# Foxground and Berry bypass

HUNTINGDALE PARK ROAD NOISE MOUND

JULY 2014

Artist's impression – part noise wall/noise mound option looking north

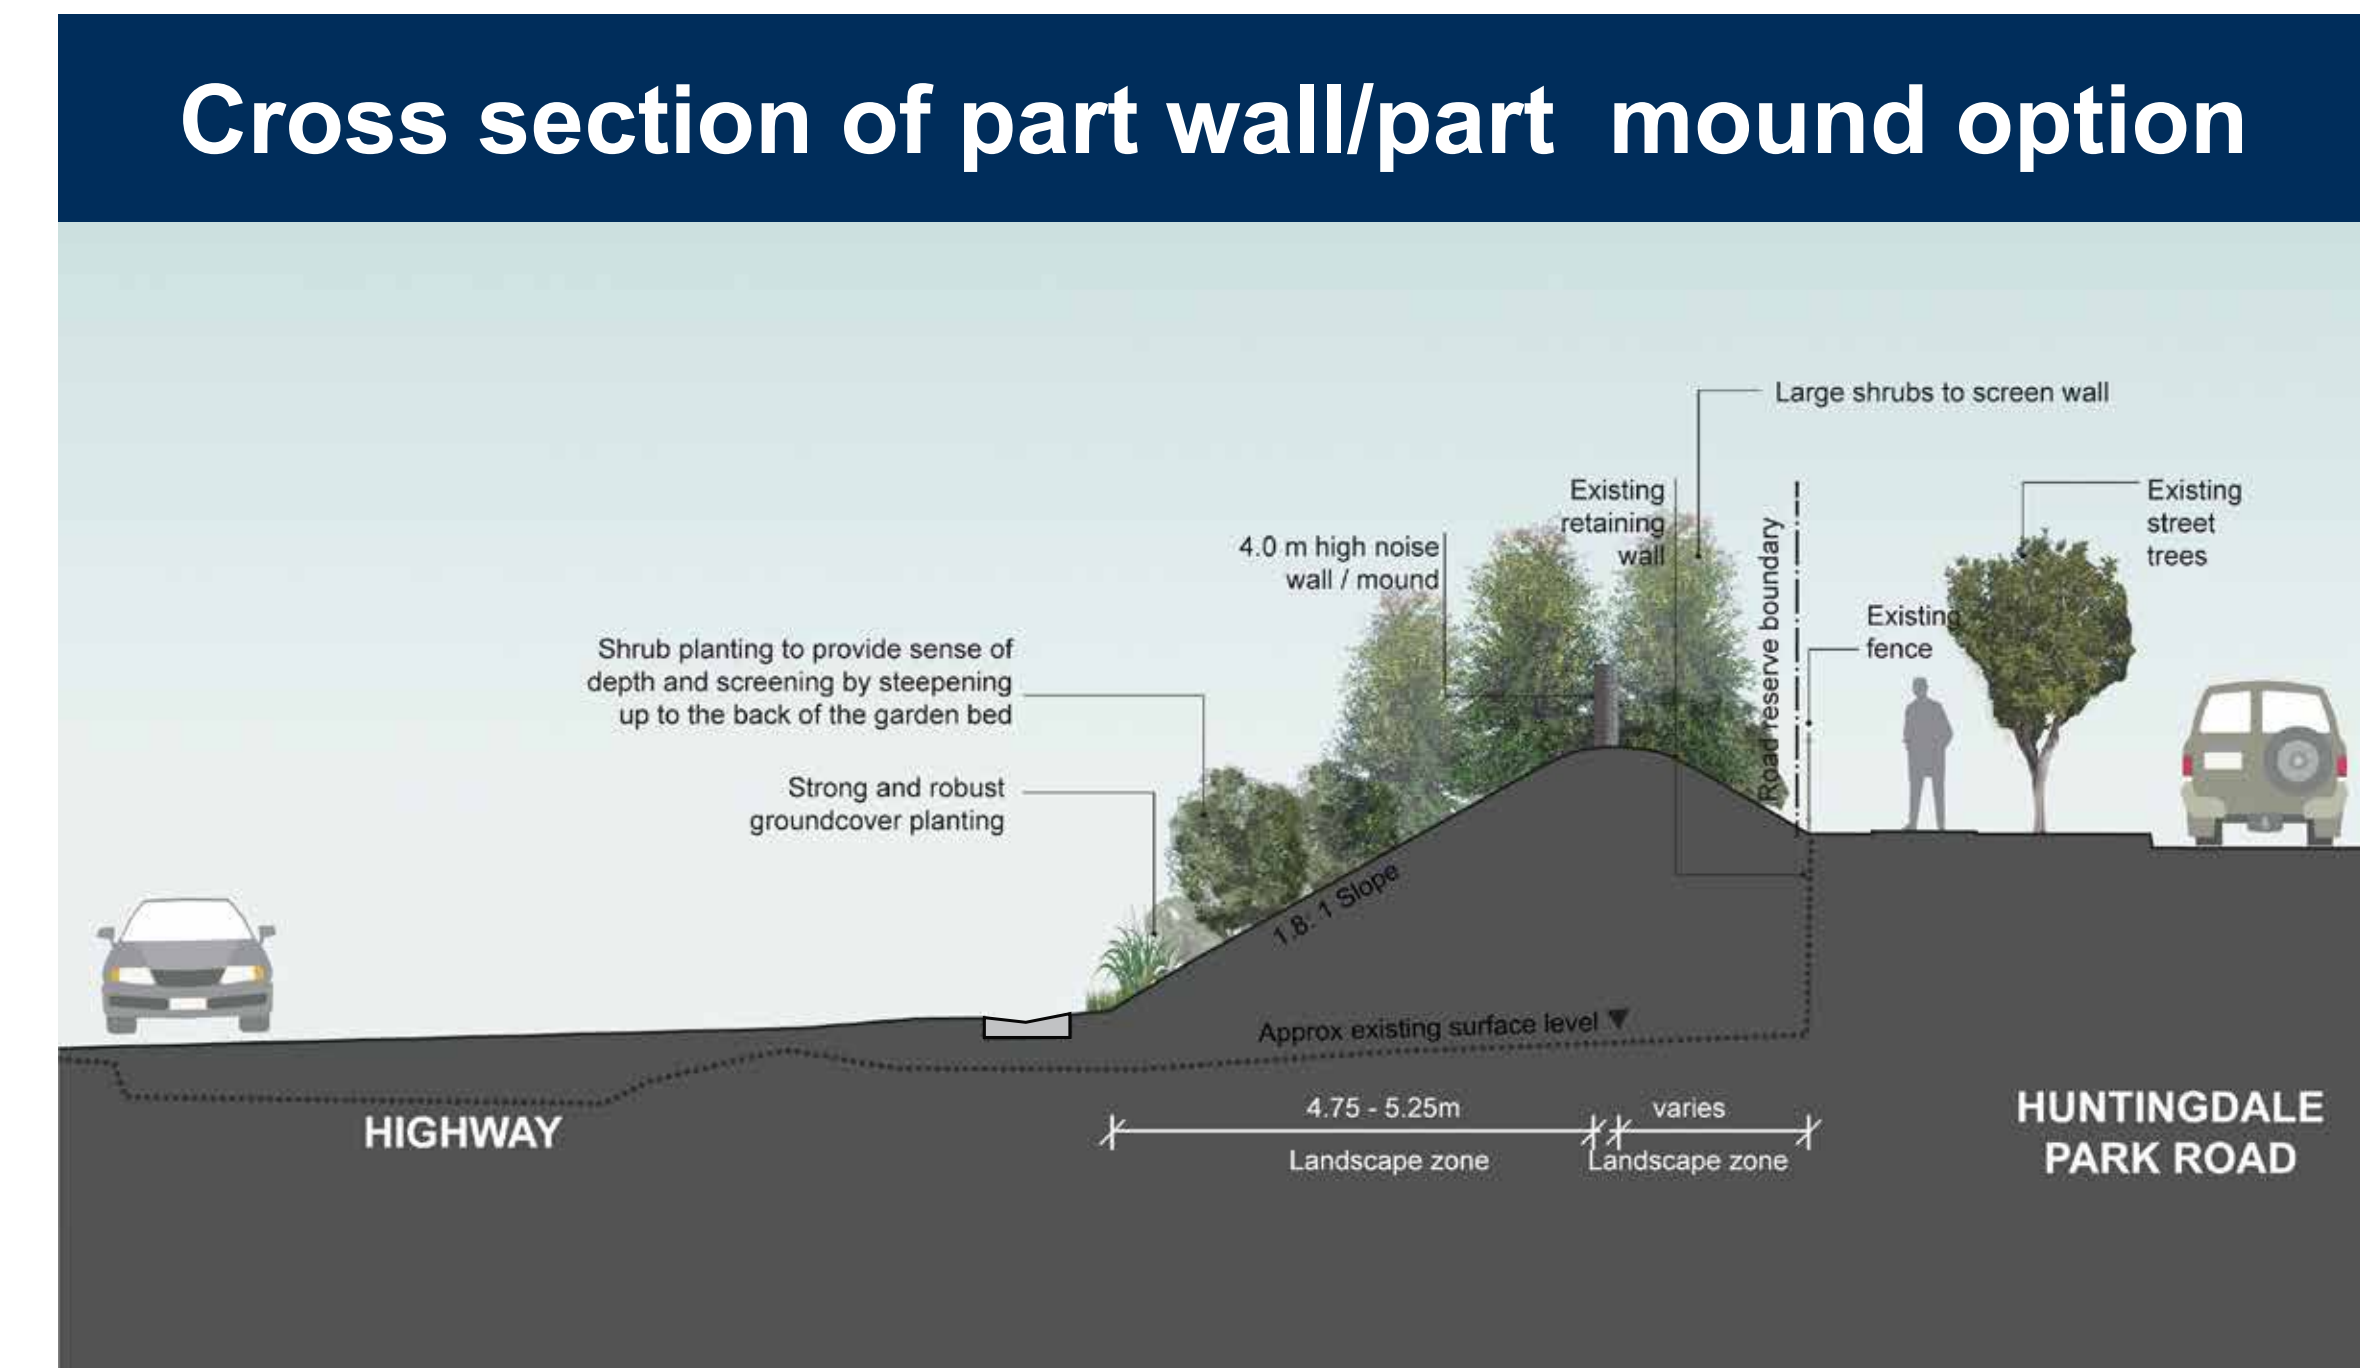
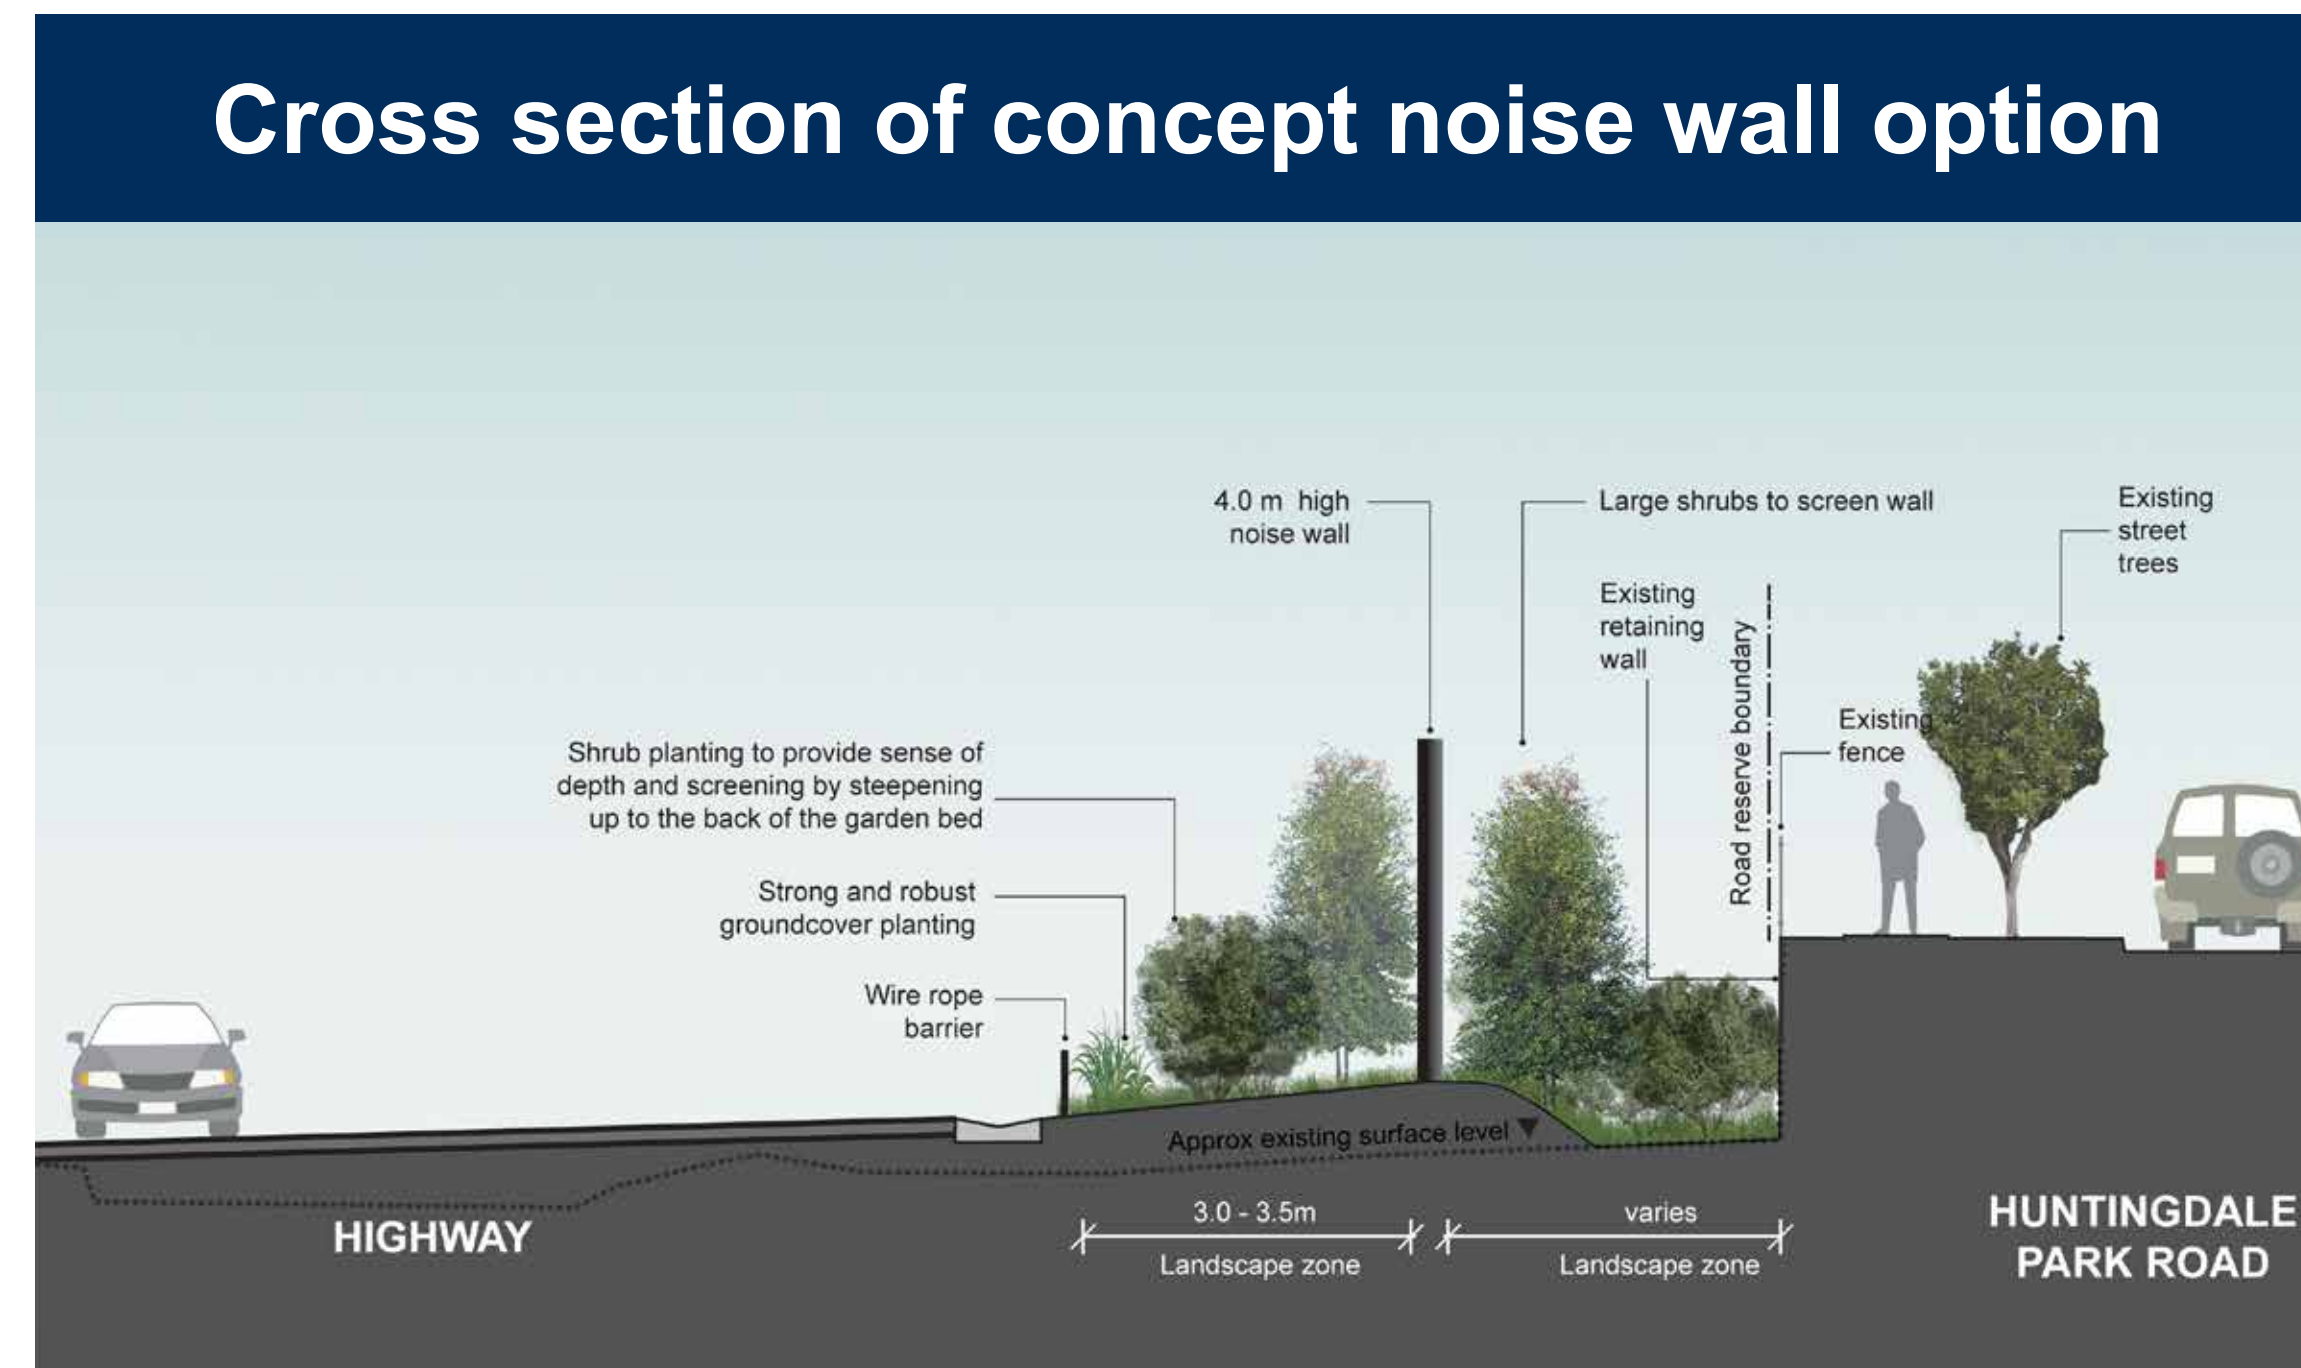
## Changes from Approved Concept Design:

- The mound and wall option has been proposed over the installation of a four metre high noise wall which was included in the concept design.
- The proposed option eliminates the need for a safety barrier and allows significantly more landscaping to improve visual amenity.

- A noise barrier made up of a noise wall about 0.8 metres high, resting on a noise mound to give an overall height of four metres above the new highway, is proposed for Huntingdale Park Road.
- The wall will be screened by vegetation on both sides to soften the view from both the new highway and adjacent residences.
